**SUBMITTAL TO THE BOARD OF SUPERVISORS
COUNTY OF RIVERSIDE, STATE OF CALIFORNIA**

SUBJECT: REGIONAL PARKS AND OPEN SPACE DISTRICT: Approve Addendums to Plans and Specifications, Accept the Low Bid, and Award the Contract for the Hidden Valley Nature Center Modernization Project; Approve Allocation of American Rescue Plan Act (ARPA) Funds; District 2. [\$4,255,041 Total Project Cost – ARP Act Coronavirus Relief Fund 21735 94%; Park Acq & Dev, District Fund 33100 6%]

1. Approve PKARC-278 Addendums No.1, No.2, No.3, No.4, No.5, No.6, and No.7, to the project bid documents issued prior to the Thursday, September 12, 2024, opening;

Project:	Bid No: PKARC-278				
Hidden Valley Nature Center Modernization		Bid Date:	9/12/2024		
Post-Bid Questions/Protest Email:	Parks-Planning@RivCo.org

LANDSCAPE SHEET LD-1

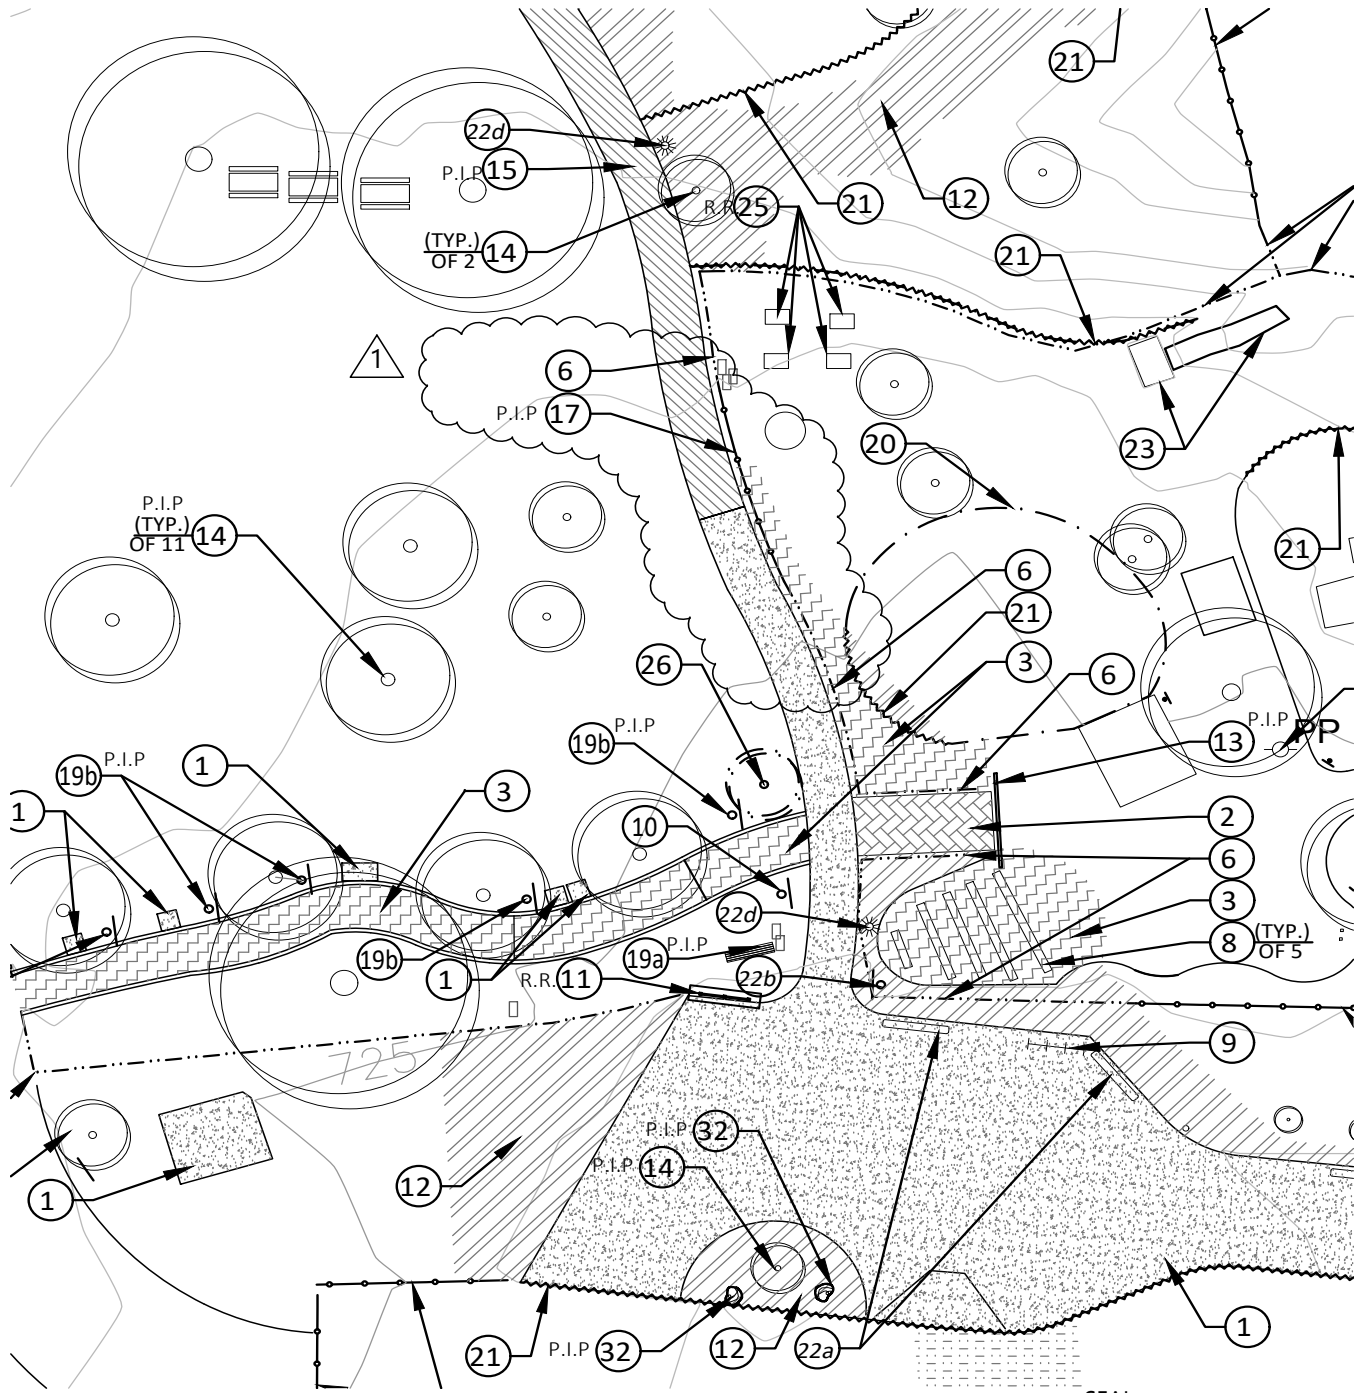
#	Plan Sheet Full Reference	Change
1	SS-2 – Septic System	New drawing sheet outlining new septic system at existing bldg.
2	SP-3 – Civil Site Plan	New drawing sheet detailing septic system at existing bldg.
3	Sheet Revision 1 of 4	Landscape Sheet LC-1 updated area of concrete to be replaced
4	Sheet Revision 2 of 4	Landscape Sheet LC-2 updated Finish Surface Qty.
5	Sheet Revision 3 of 4	Landscape Sheet LD-1 updated area of concrete to be demolished
6	Sheet Revision 4 of 4	Landscape Sheet LD-2 updated concrete qty. to be demolished.

ADDENDUM #3 8/15/24
CONCRETE AND SEPTIC

SHEET SS-1

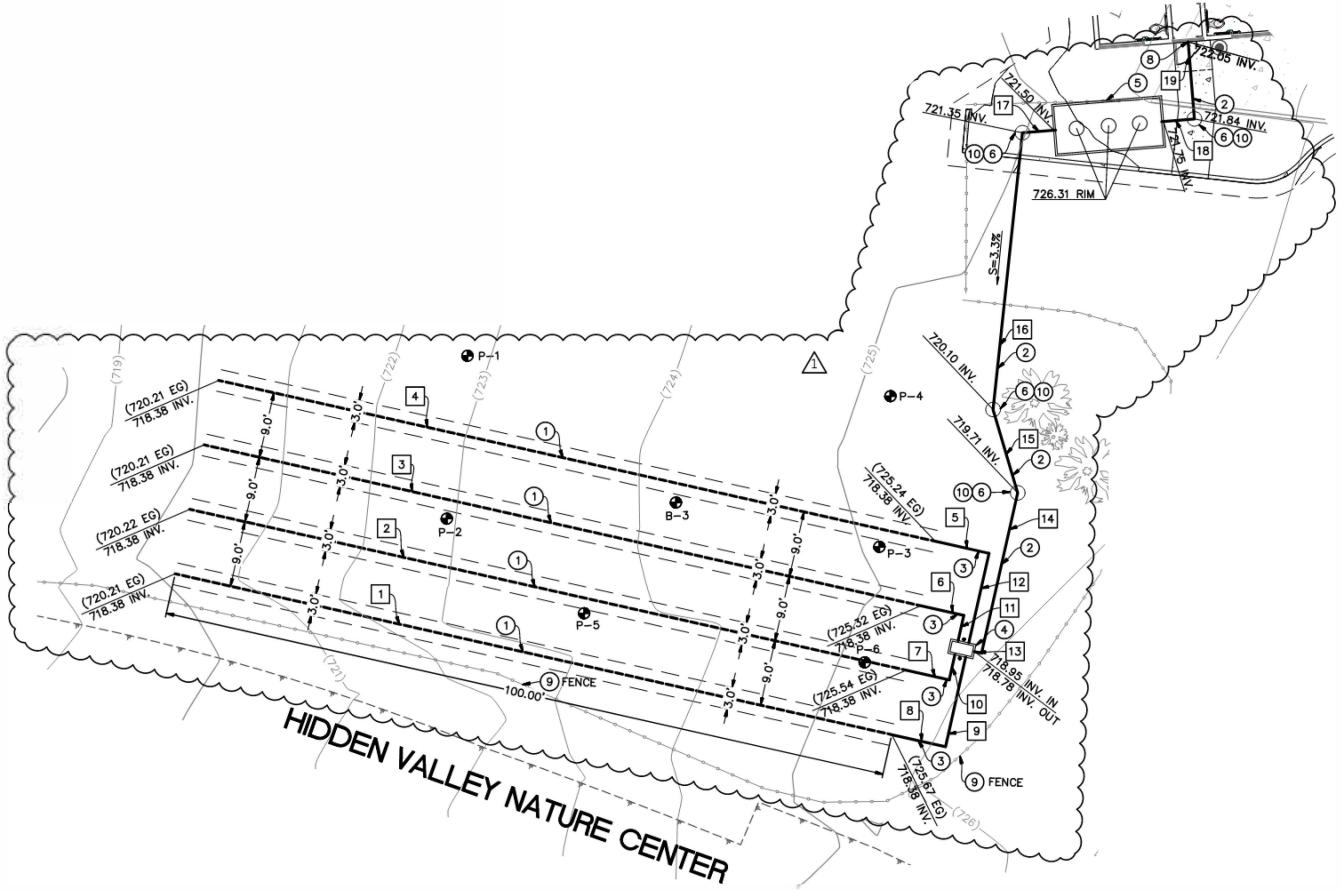
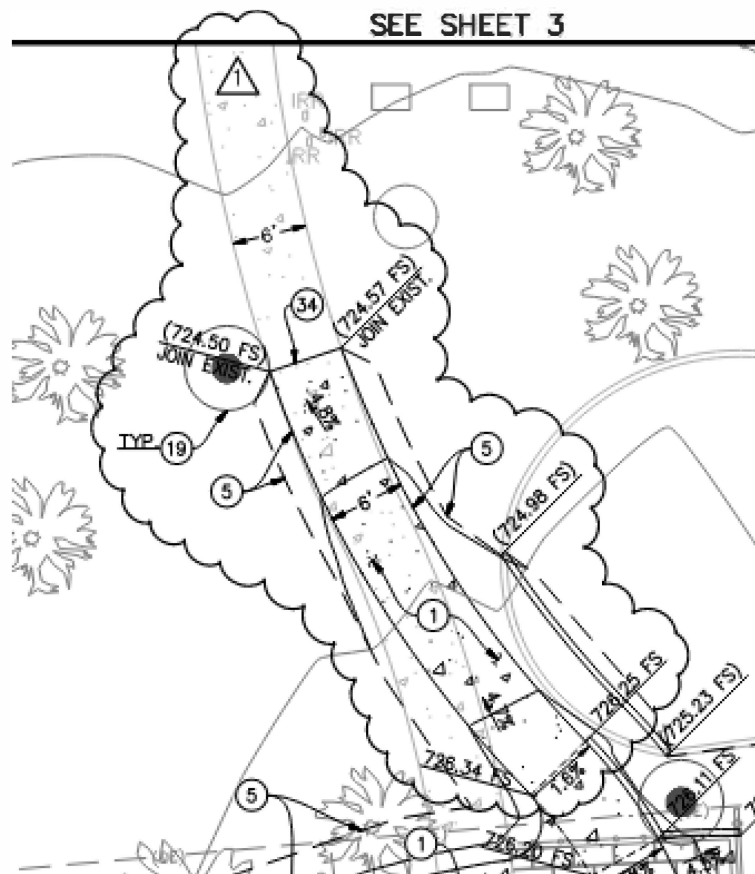
#	Plan Sheet Full Reference	Change
1	SS-1 – Revision to Detail	Issued revised detail and dimensions for the restroom septic leach field
2	GP-3 and GP-4 – Revision to Detail	Issued a single page revision which applies to both sheets to adjust dimensions associated with the sidewalk.

**ADDENDUM 4
ENTRANCE RESTROOM
SEPTIC SYSTEM REVISION**

- ① CONSTRUCT LEACH FIELD AS SHOWN ON PLANS AND PER TYPICAL LEACH FIELD CROSS SECTION, SEE SHEET SP-2.
- ② CONSTRUCT 6" SDR-35 PVC PIPE AS SHOWN ON PLANS AND TRENCH BACKFILL DETAIL, SEE SHEET SP-2.
- ③ CONSTRUCT 4" SDR-35 PVC PIPE AS SHOWN ON PLANS AND TRENCH BACKFILL DETAIL, SEE SHEET SP-2.
- ④ CONSTRUCT 11" X 15.5" JENSEN MODEL D5 PRECAST DISTRIBUTION BOX OR APPROVED EQUAL.
- ⑤ CONSTRUCT 15' X 17' OLDCASTLE MODEL CST-3500 PRECAST SEPTIC TANK OR APPROVED EQUAL.
- ⑥ CONSTRUCT 6" SEWER CLEAN OUT AS SHOWN ON PLANS AND PER R.C.T.D. STANDARD NO. 603, SEE SHEET SP-2.
- ⑦ PROTECT IN PLACE EXISTING TREE.
- ⑧ CONNECT TO EXISTING PREMANUFACTURED RESTROOMS SEWER PIPE AS REQUIRED.
- ⑨ PROTECT IN PLACE AS NOTED.
- ⑩ CONSTRUCT 5" THICK LAYER OF 3/8" TO 1/2" CRUSHED ROCK BELOW CONCRETE COLLAR CLEAN OUT.

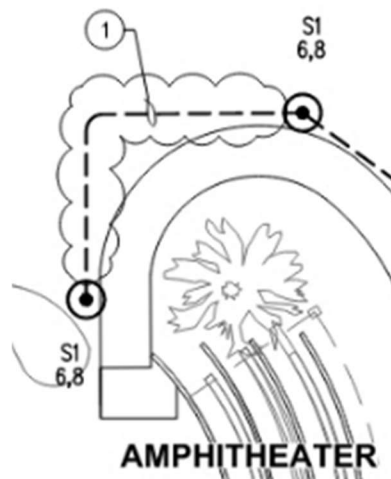
- Scope removed near new pavilion:** The scope of work to add a concrete walk and small gathering area adjacent to the fence line with a new light pole and 2 benches is hereby removed from scope. This includes work associated with this area on all plans inclusive of demolition, electrical, and architectural.

Irrigation shall be revised to generally follow the line of the revised walkway.

The area shall now be constructed per this revised walkway approach:

LANDSCAPE SHEET LA-1

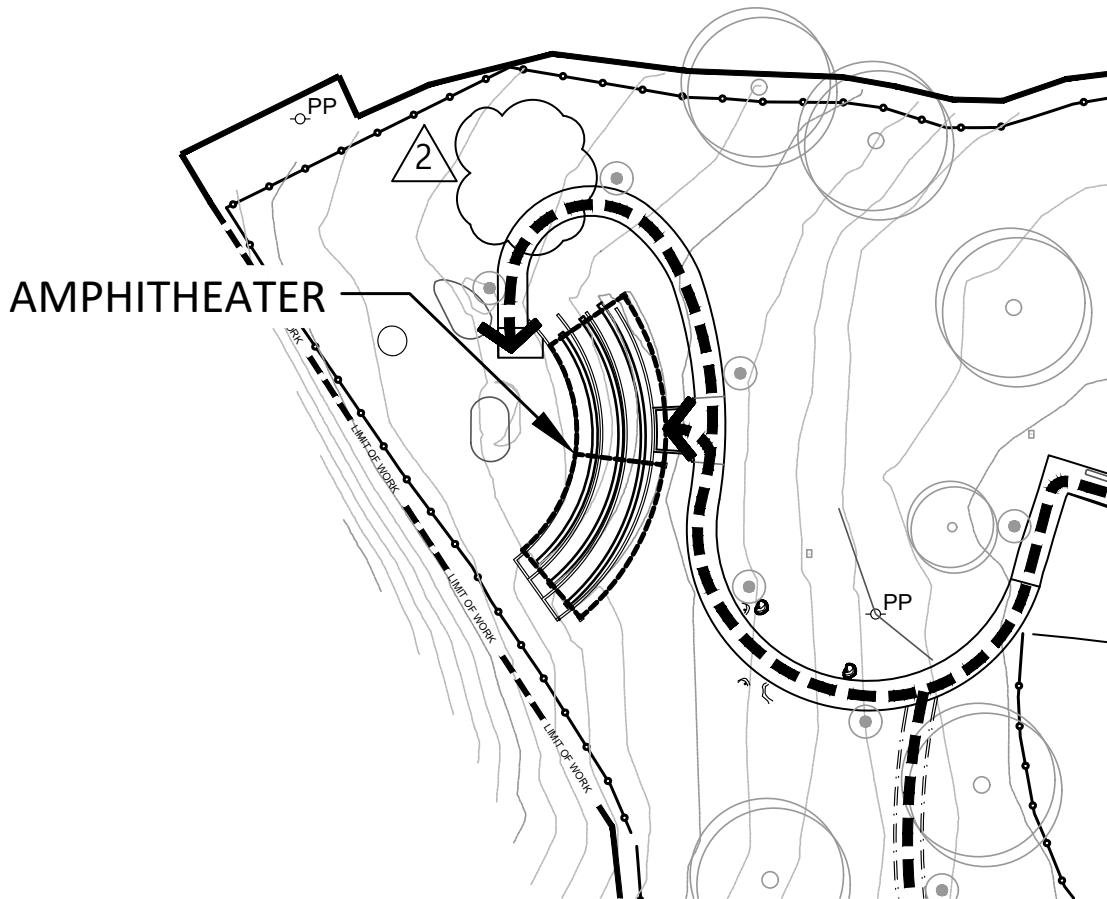
4. Revise key detail on Sheet LA-1 Accessibility with an updated Accessibility path of Travel area.

LANDSCAPE SHEET LD-1

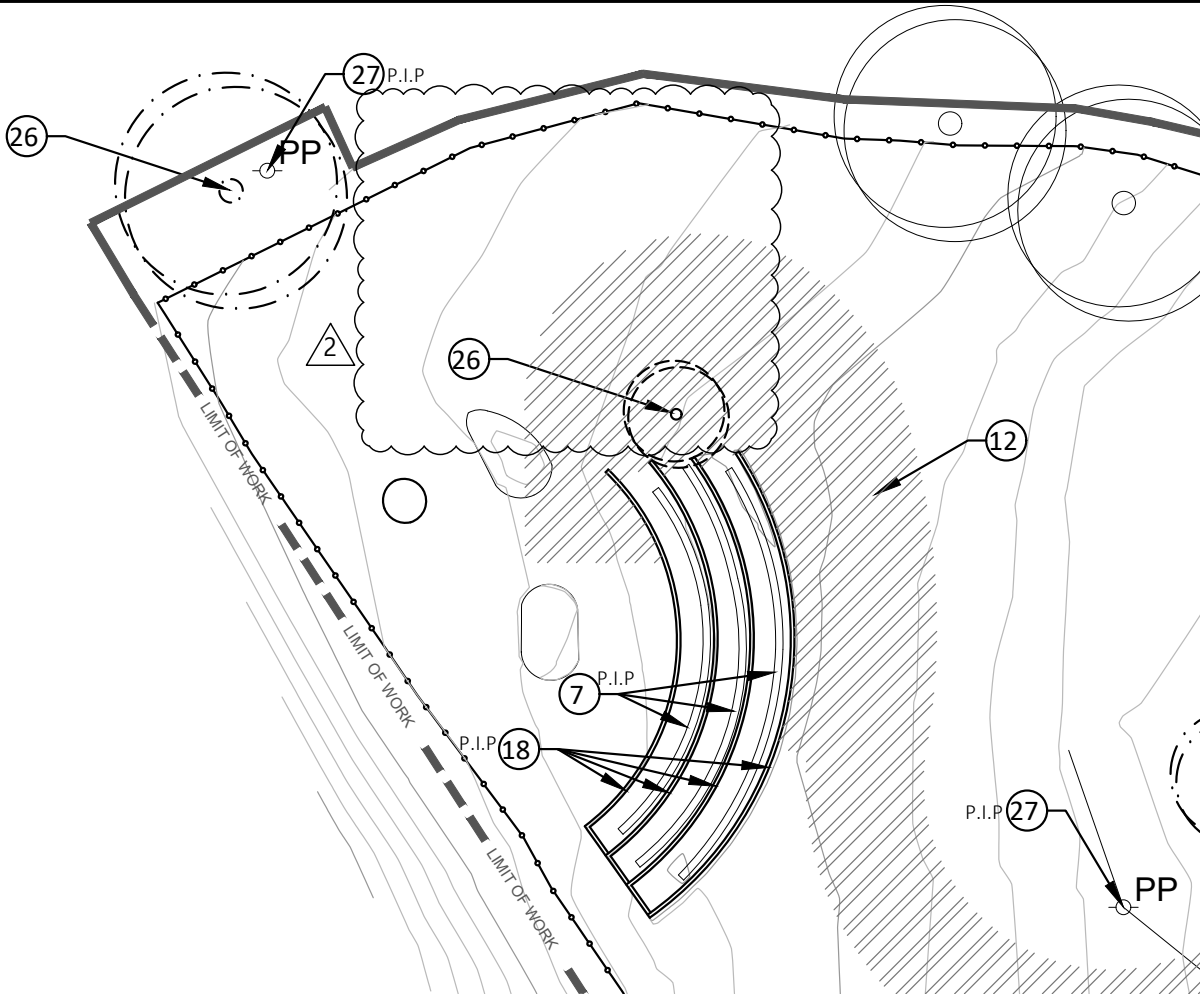
5. Revise key detail on Sheet LD-1 Demolition to incorporate a modification to the Demolition Legend for the concrete quantity to be demolished.

ADDENDUM NO.6
PCC REMOVAL

LANDSCAPE SHEET LD-2

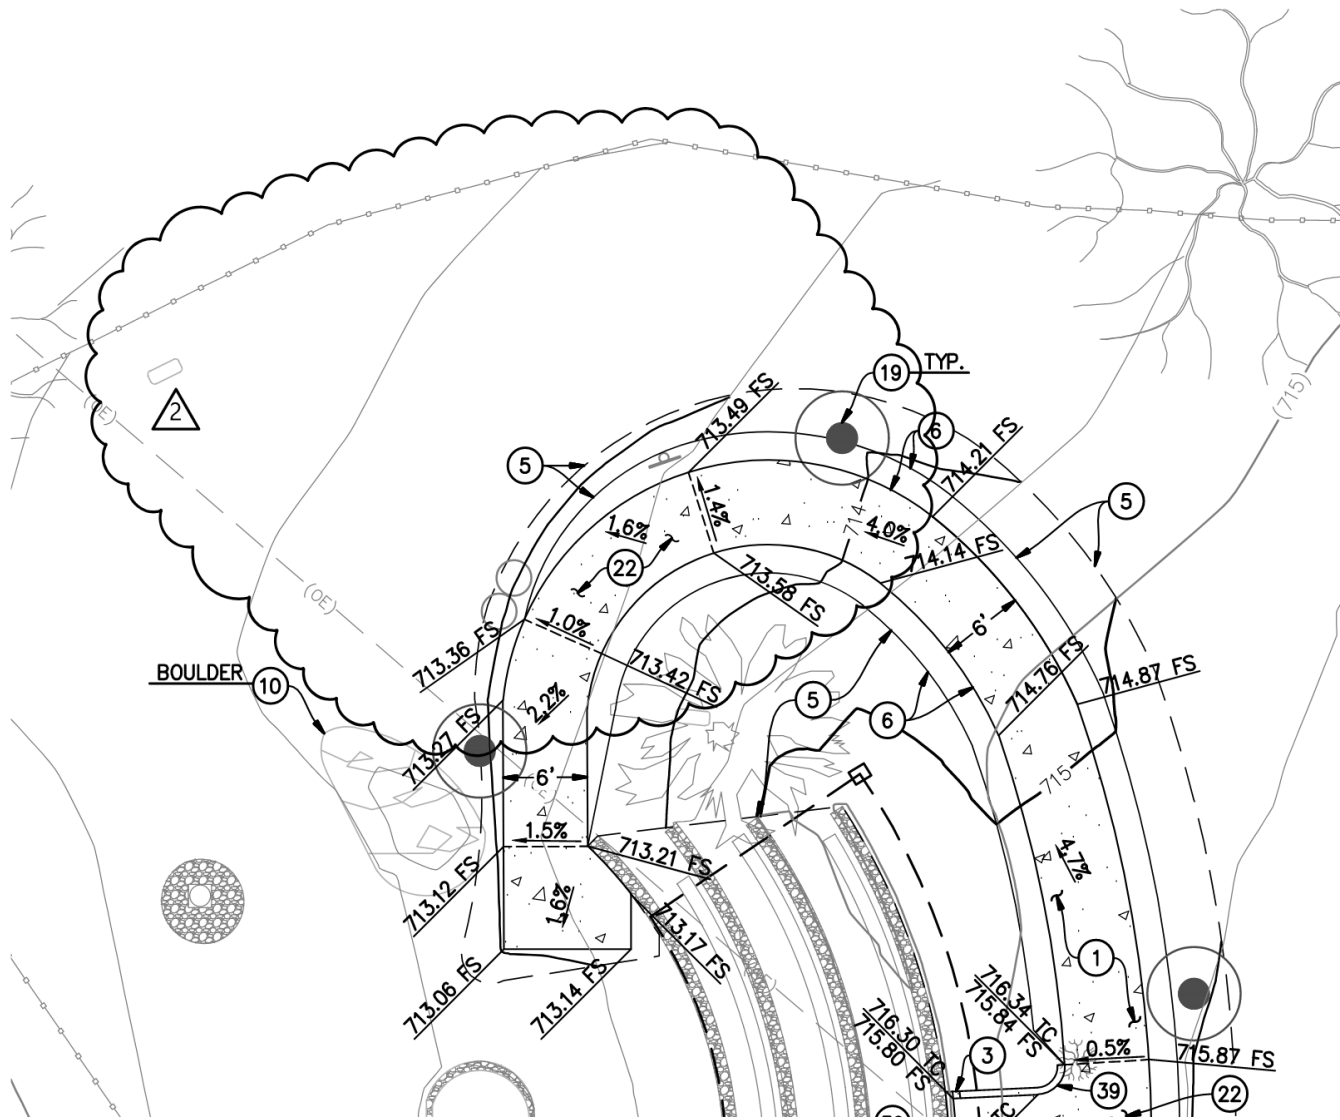
6. Revise key detail on Sheet LD-2 Demolition to incorporate a modification to the concrete quantity to be demolished and area.

HIDDEN VALLEY NATURE CENTER	PREPARED FOR: RIVERSIDE COUNTY PARKS	<p>SCALE:NTS</p>	
	DESCRIPTION: ADDENDUM NO.6 PCC REMOVAL

SHEET GP-1

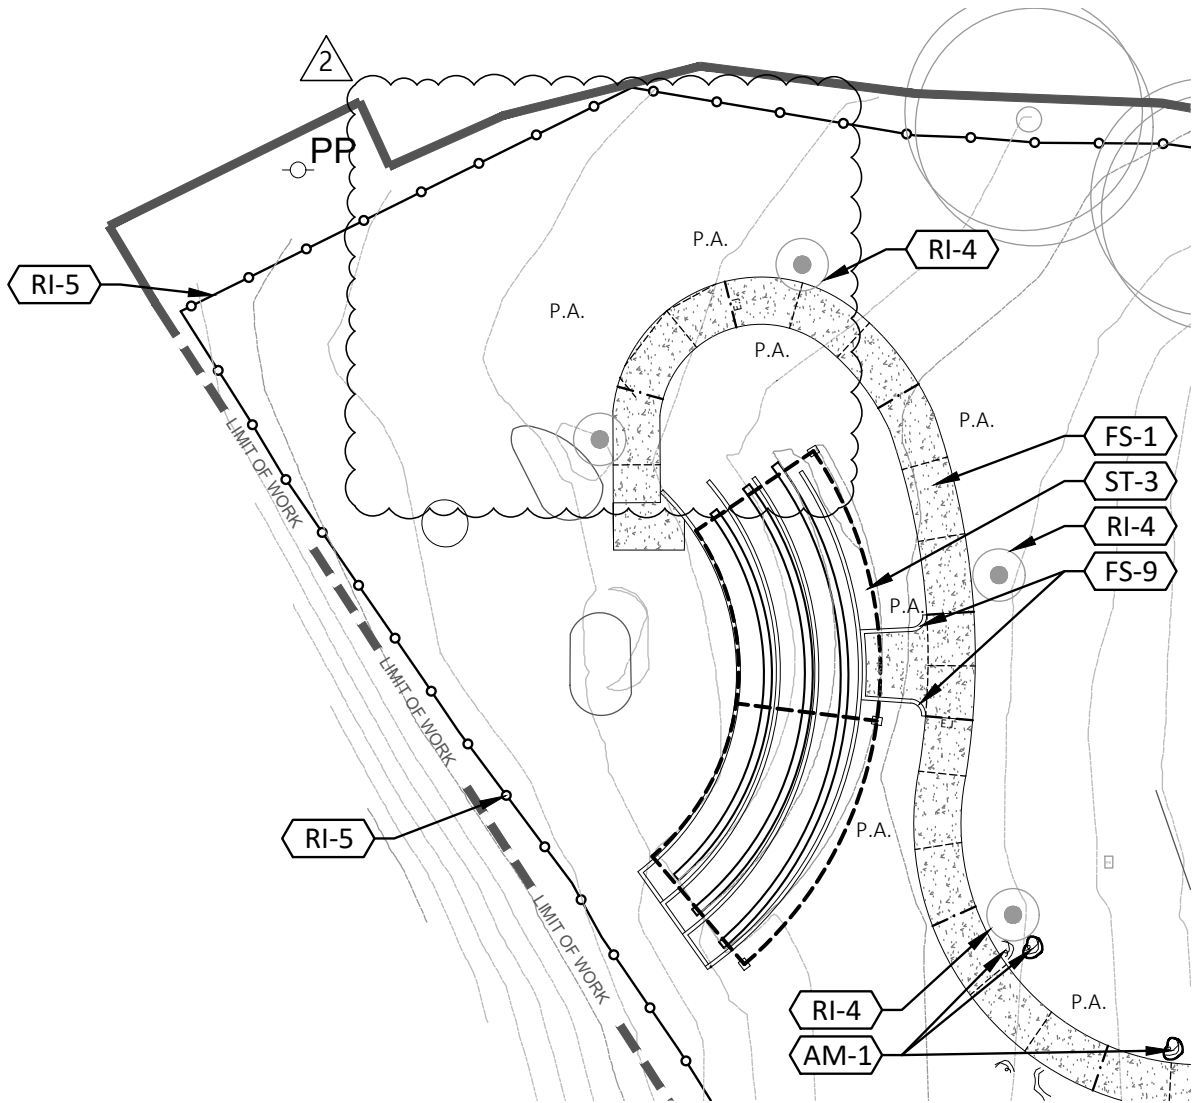
7. **Revise Sheet GP-1 Civil Site Grading Plan** to address revised area of work.
8. **Revise Sheet LC-2 Construciton Plan** to address revised area of work and Finish Surface Quantity.
9. **Revise Sheet LI-2 Irrigation Plan** to update irrigation.
10. **Revise Sheet LP-1 Planing Plan** Planting Legend for plant and reseed quantities.
11. **Revise Sheet LP-2 Planing Plan** to revise plant and reseed quantity.

**ADDENDUM 6
PROPOSED PCC
PAD REMOVAL**
